*Summary of the discussion  
for the commissioning session*

*2<sup>nd</sup> ATF2 Project Meeting*

*6/ 1/ 2006*

*T.Okugi (KEK)*

## *Around Final Doublet – Monitor Configuration*

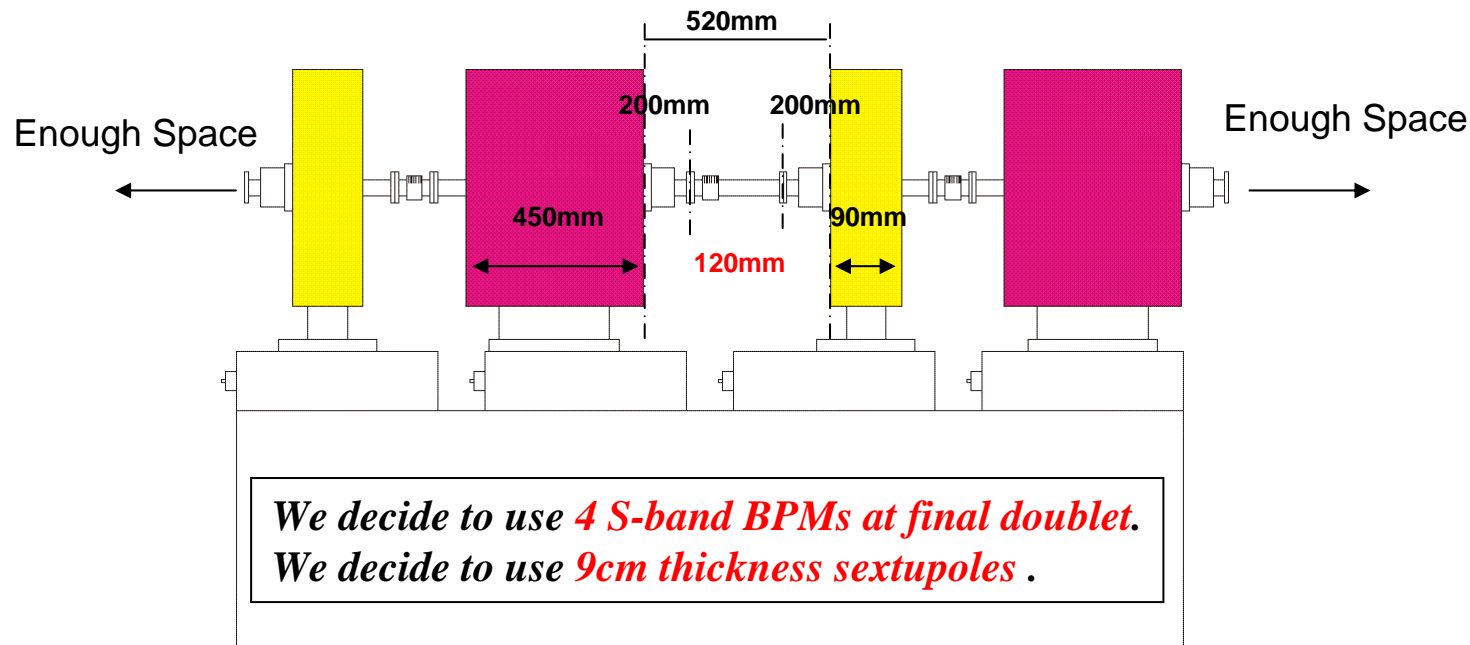
*The coils for sextupole will be rewiring.*

*We will make an adapter to avoid the interference between the QC3 coil and S-band cavity BPM.*

*What we should do is to estimate the length of the adapter for quadrupole.*

*If the length of adapter is shorter than 20mm,  
we can use the 100mm bellows chamber.*

*If **not**, we will consider to use shorter bellows chamber  
or to make the distance between quadrupole and sextupole wider by putting counter-weight  
on sextupole mover  
or to make the suport table lengthen.*

## *Around SF6 and SF5 – Collimator Configuration*

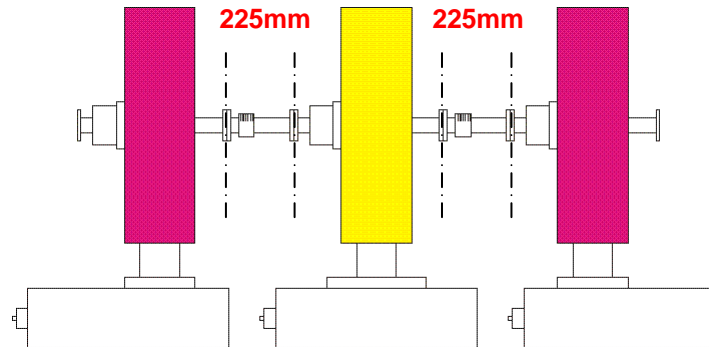
*We decide to use 9cm thickness sextupoles for SF5 and SF6.*

*We decide not to put the collimators around SF6 to avoid the laser wire background.*

*We decide to put the 15mm $\phi$  fixed collimators around SF5.*

*We must put the 5cm bellows at the both side of collimators.*

*Laser wire group suggested that the collimators around SF5 is also not good for them.*

*Shintake monitor group suggested*

*that the collimators should be movable and need both X and Y directions.*

*We need more discussion with laser wire group and Shintake monitor group.*

## *Around QD6*

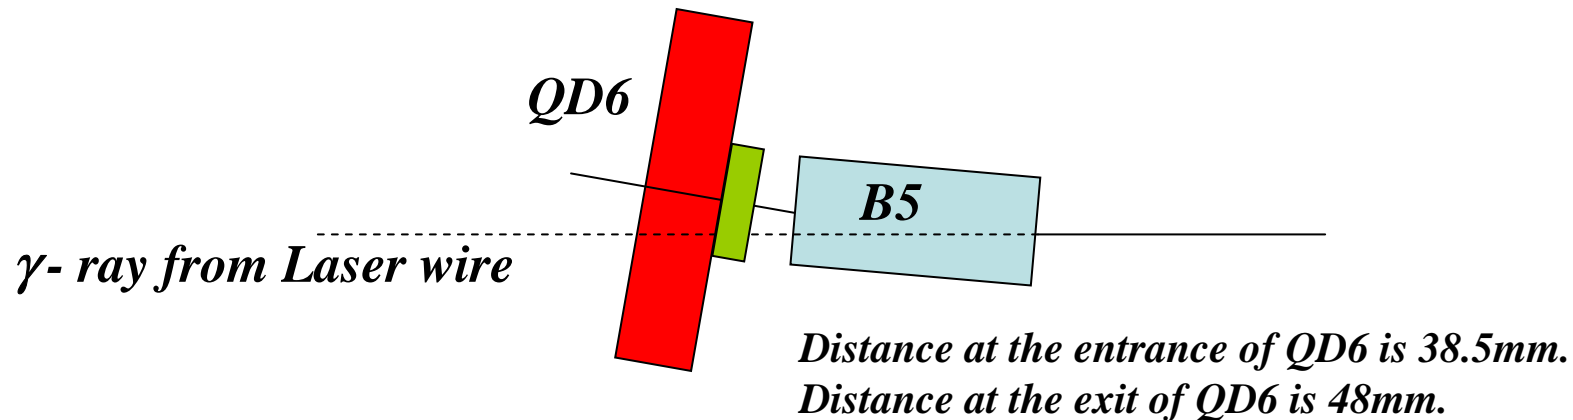
*We decide to use the **C-band cavity BPM for QD6**, too.*

*Inference of  $\gamma$ - ray path and flange will be avoided by using the special type flange.*

*Inference of  $\gamma$ - ray path and cavity BPM will be avoided by using the special adopter.*

### *Requirement from Laser wire group*

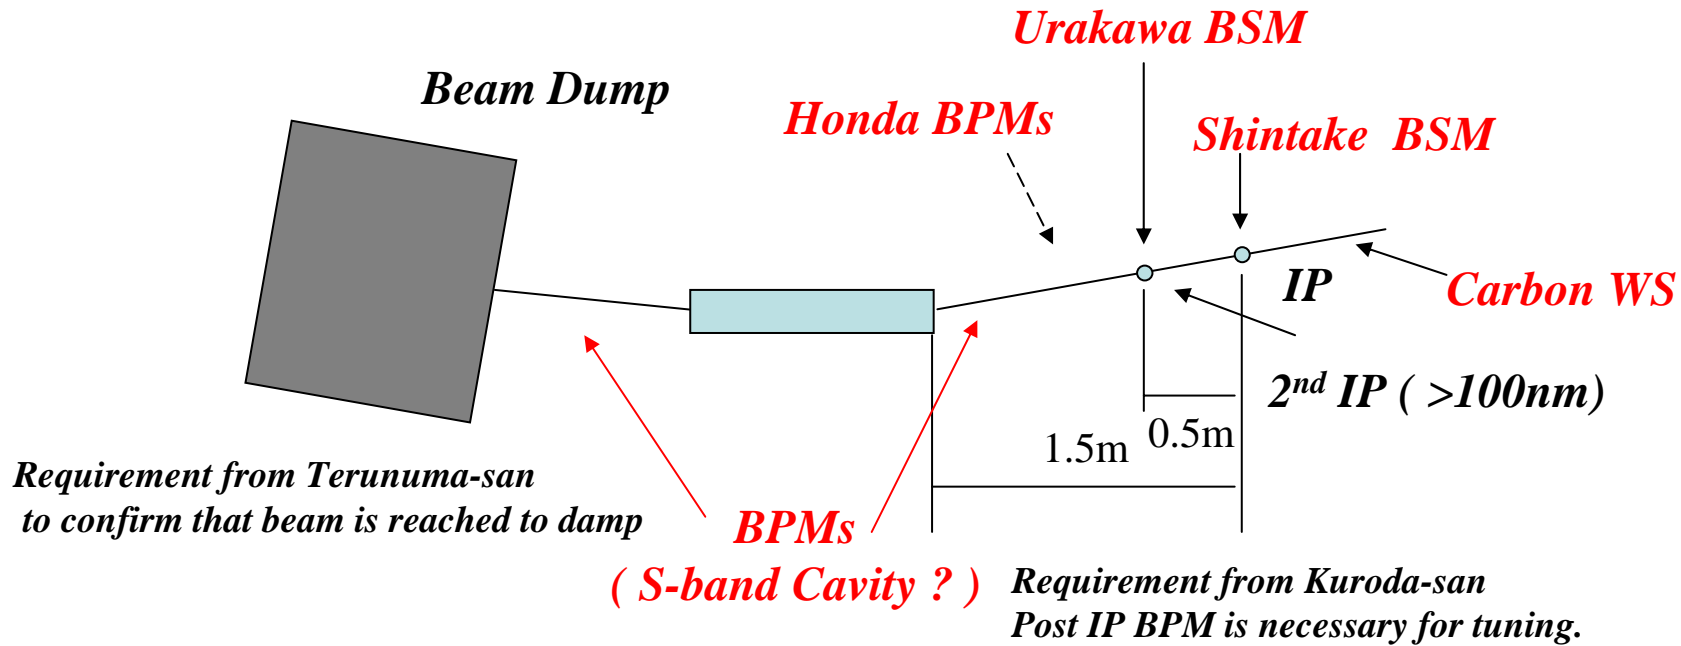
*The clearance of  $\gamma$ - ray at QD6 should be larger than 50mm  $\phi$ .*

*However, the aperture of  $\gamma$ -ray is limited by the upstream magnet and the cavity BPMs.*

*Is this clearance actually necessary ?*

*Unfortunately, we cannot make a good idea for the problem in the meeting.*

- 1) To evaluate the **actual number of the  $\gamma$ - ray clearance**.*
- 2) To make a special quadrupole magnets.*
- 3) To move the position of LW to downstream. ...*

# Beam Line for Laser Wire Scanner

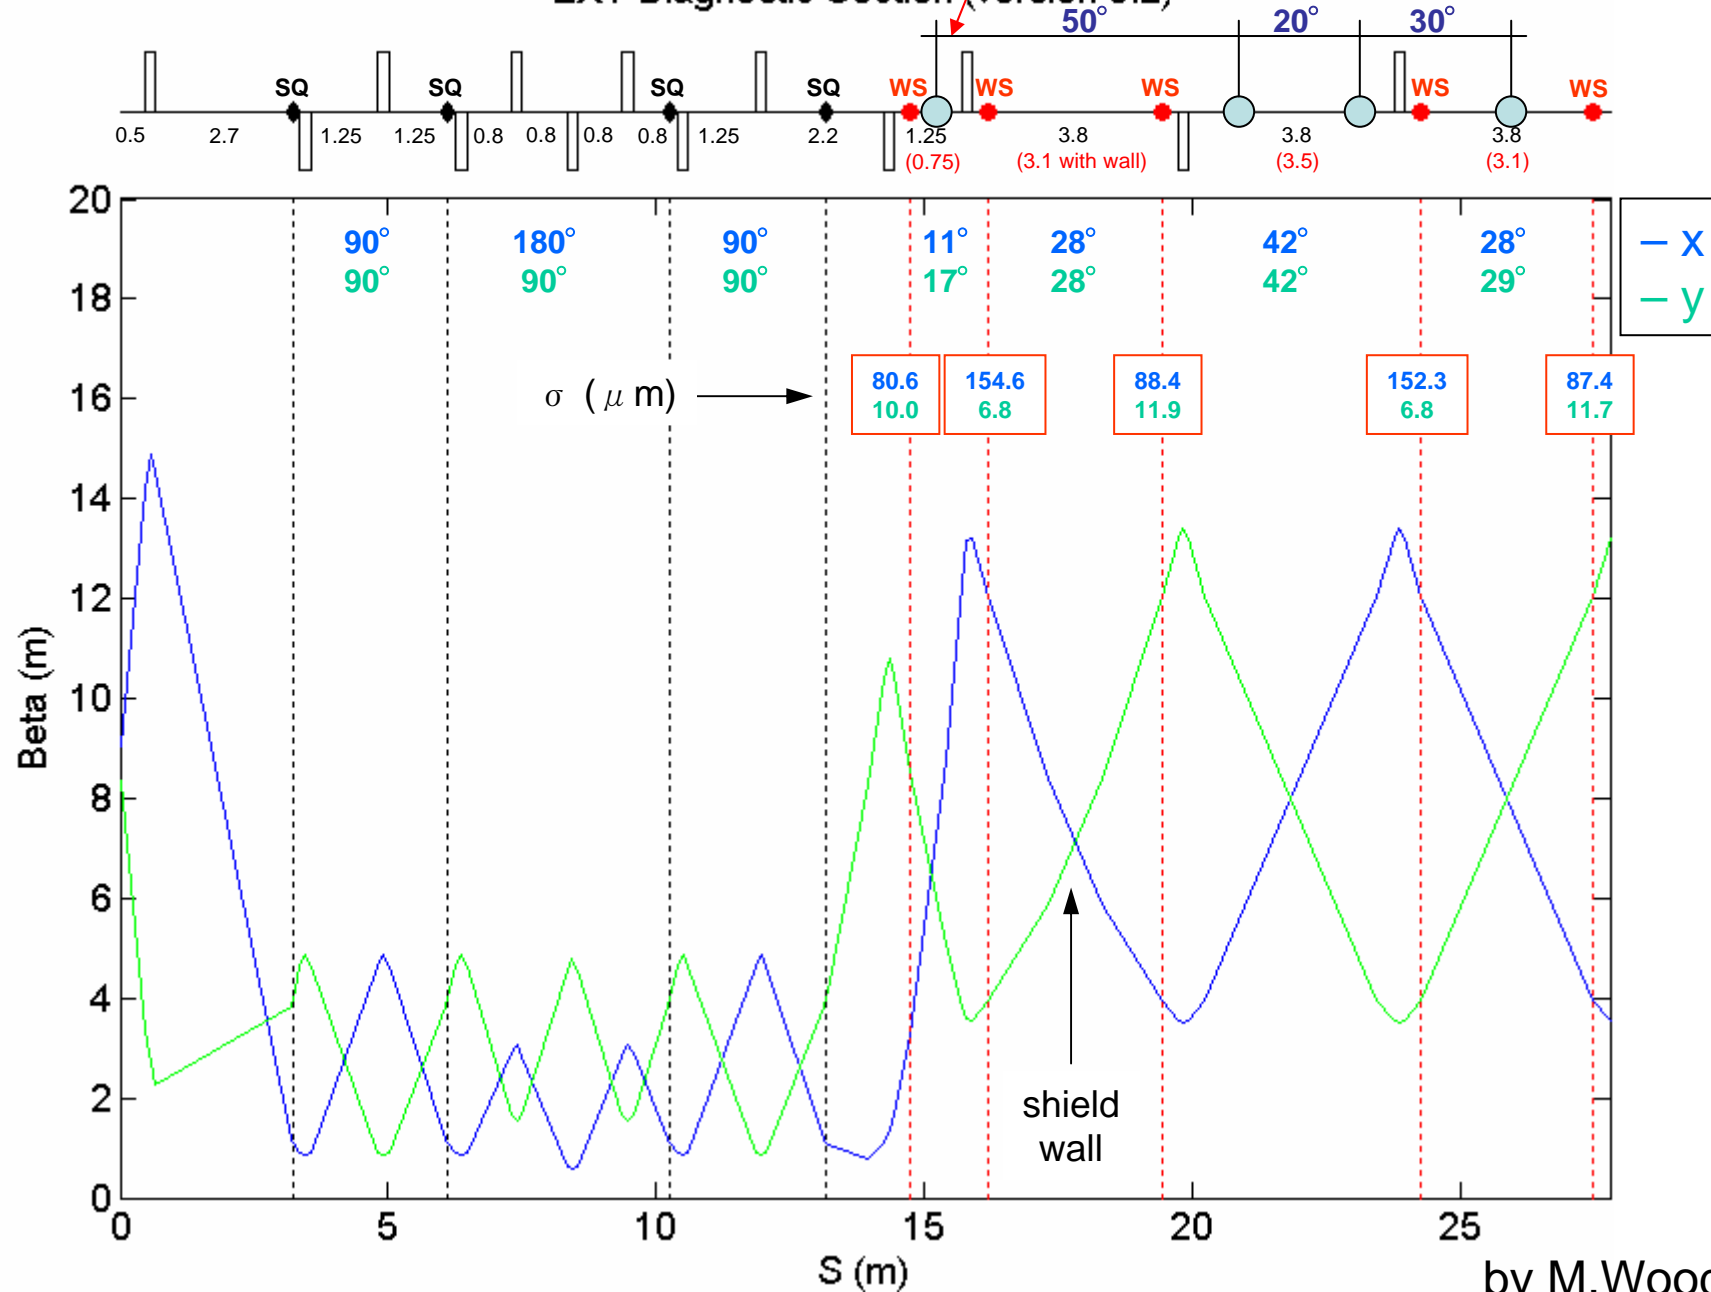
*1) Is it possible to change **the laser wire chamber location to downstream** ?  
( in order to make small  $\gamma$ ray size at the QD6 )*

*2) Is it possible to **remove the collimator** for Shintake monitor from beam line ?*

*3) Can we make **a small beam size** at the ATF2 laser wire location ?*

*-> We have **some space to put laser wire chambers**,  
but the locations are just **matching section**,  
we must investigate whether the locations are appropriate for laser wire or not.*

*-> It is better to use **the movable collimators**.  
We must investigate whether the movable collimators can be put or not.*

*-> It is **possible to make a small beam size** at laser wire IP,  
but no one knows **whether can we pass the beam to the damp with small background**.  
We cannot make an answer for the question now without any investigations.*
